Clark County Building Safety Division

Two One - Hour Townhouse Walls

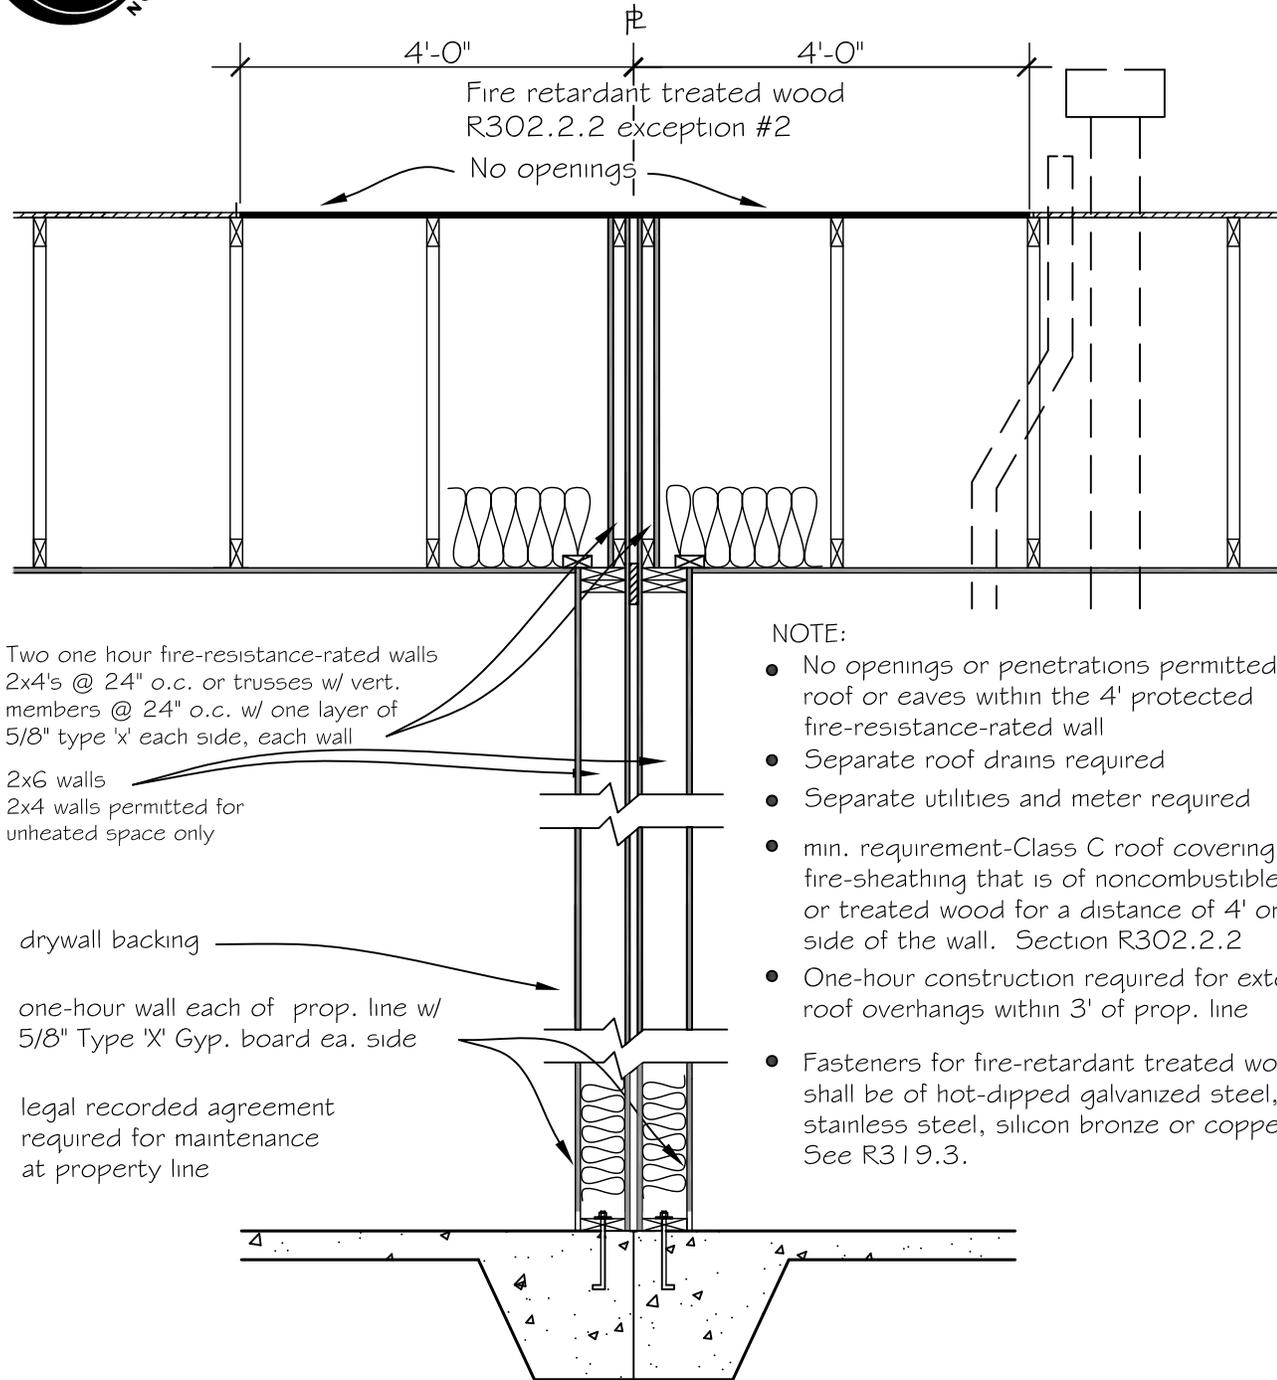
Please provide the manufactures installation spec sheets for the **approved penetration firestop system's** being used on the project for both the plan review process and onsite for field inspections.
